UNITED STATES
NUCLEAR REGULATORY COMMISSION

SUBJECT: DRESDEN - ISSUANCE OF AMENDMENTS - REVISED PRESSURE-
TEMPERATURE LIMITS (TAC NOS. MA8346 AND MA8347)

Amendment No. 179
License No. DPR-19

Amendment No. 174
License No. DPR-25

FIGURE 3.6.K-1

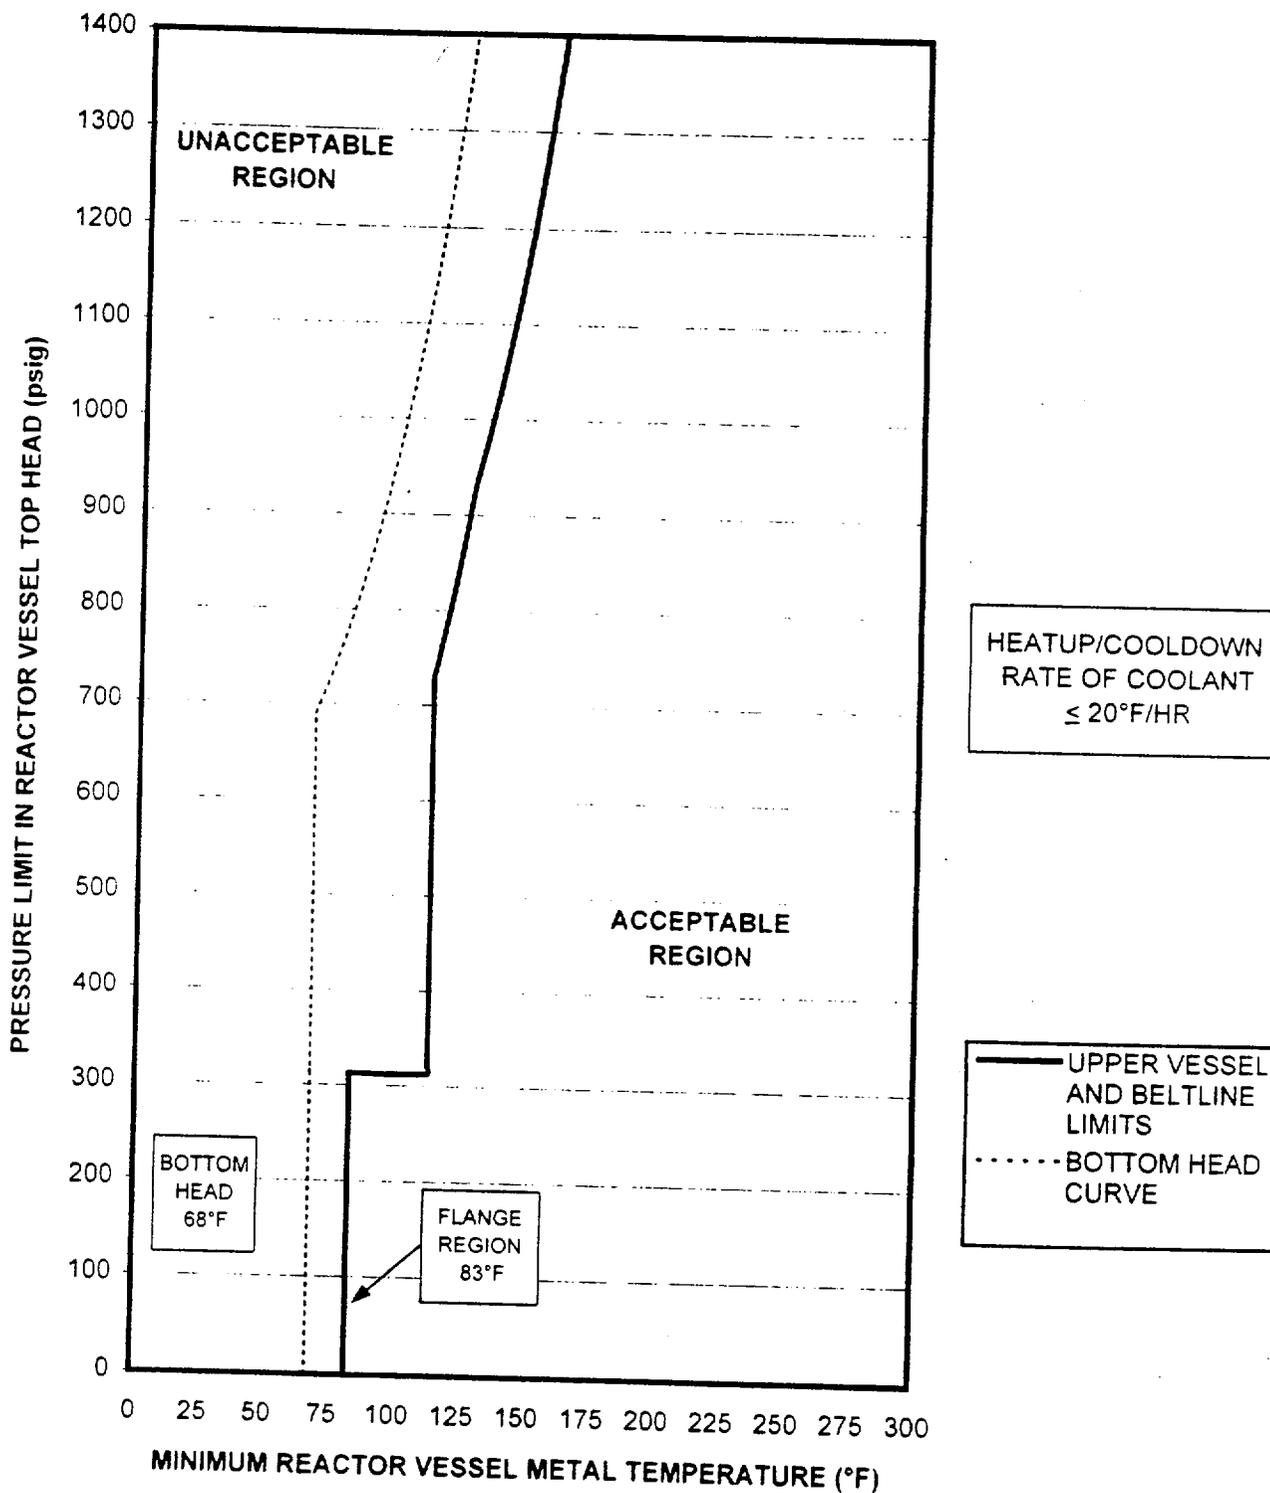
1. Pressure Testing:
 - a. The reactor vessel metal temperature and pressure shall be maintained within the Acceptable Regions as shown on Figure 3.6.K-1 with the rate of change of the primary system coolant temperature $\leq 20^{\circ}\text{F}$ per hour, or
 - b. The rate of change of the primary system coolant temperature shall be $\leq 100^{\circ}\text{F}$ per hour when reactor vessel metal temperature and pressure is maintained within the Acceptable Regions as shown on Figure 3.6.K-2.
2. Non-Nuclear Heatup and Cooldown and low power PHYSICS TESTS:
 - a. The reactor vessel metal temperature and pressure shall be maintained within the Acceptable Regions as shown on Figure 3.6.K-2, and
 - b. The rate of change of the primary system coolant temperature shall be $\leq 100^{\circ}\text{F}$ per hour.

- b. The reactor vessel metal temperature and pressure shall be determined to be within the Acceptable Regions on Figures 3.6.K-1 through 3.6.K-2.
2. For reactor critical operation, determine within 15 minutes prior to the withdrawal of control rods and at least once per 30 minutes during primary system heatup or cooldown

As indicated in Figure 3.6.K-1 for pressure testing, the minimum metal temperature of the reactor vessel shell is 83°F for reactor pressure less than 312 psig. This 83°F minimum boltup temperature is based on a RT_{NDT} of 23°F for the electroslag weld immediately below the vessel flange and a 60°F conservatism required by the original ASME Code of construction. The bottom head region limit is established as 68°F, based on moderator temperature assumptions for shutdown margin analyses. At reactor pressures greater than 312 psig, the minimum vessel metal temperature is established as 113°F. The 113°F minimum temperature is based on a closure flange region RT_{NDT} of 23°F and a 90°F conservatism required by 10 CFR Part 50 Appendix G. Beltline curves as a function of vessel exposure for 32 effective full power years (EFPY) are presented.

Figure 3.6.K-1 is governing for applicable pressure testing with a maximum heatup/cool-down rate of 20°F/hour.

FIGURE 3.6.K-3

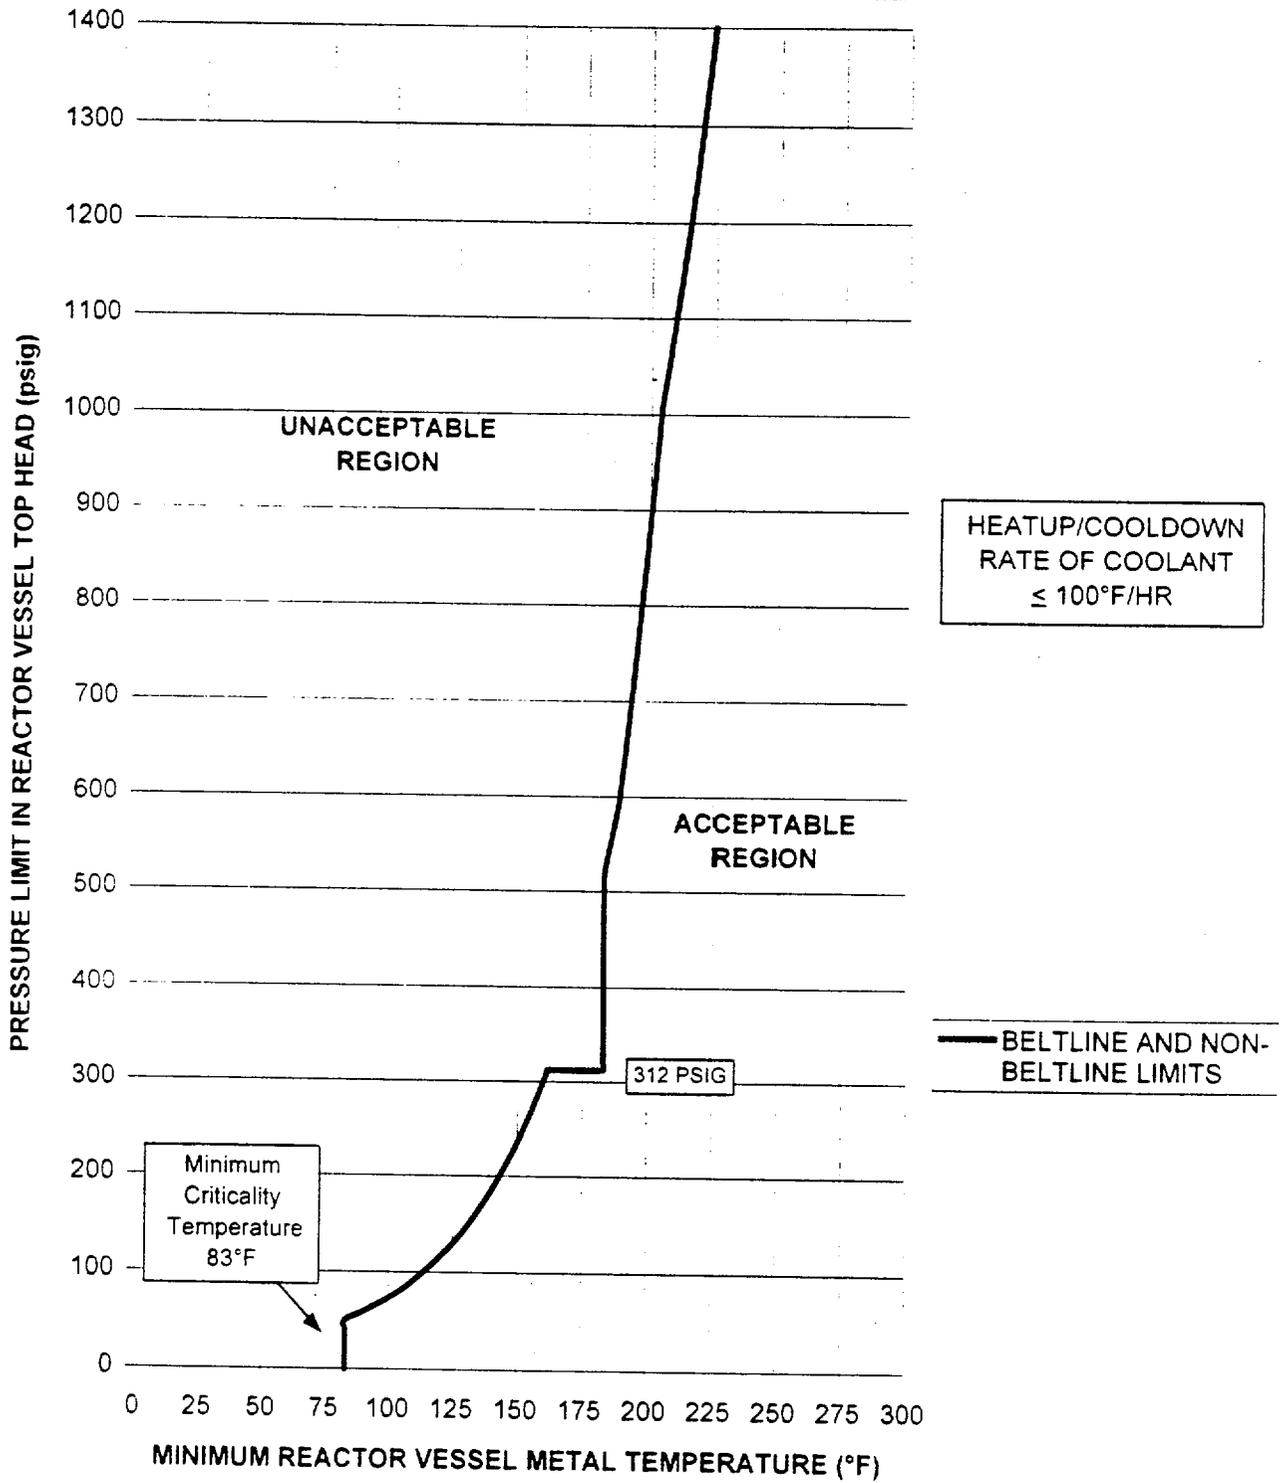
- a. The rate of change of the primary system coolant temperature to be within the limits, and
 - b. The reactor vessel metal temperature and pressure to be within the Acceptable Region on Figure 3.6.K-3.

3. Nuclear Heatup and Cooldown:
 - a. The reactor vessel metal temperature and pressure shall be maintained within the Acceptable Region as shown on Figure 3.6.K-3, and
 - b. The rate of change of the primary system coolant temperature shall be $\leq 100^{\circ}\text{F}$ per hour.
4. The reactor vessel flange and head flange temperature $\geq 83^{\circ}\text{F}$ when reactor vessel head bolting studs are under tension.

The core critical operation curve shown in Figure 3.6.K-3, is generated in accordance with 10CFR Part 50 Appendix G which requires core critical pressure-temperature limits to be 40°F above any pressure testing or non-nuclear heatup/cool-down limits.
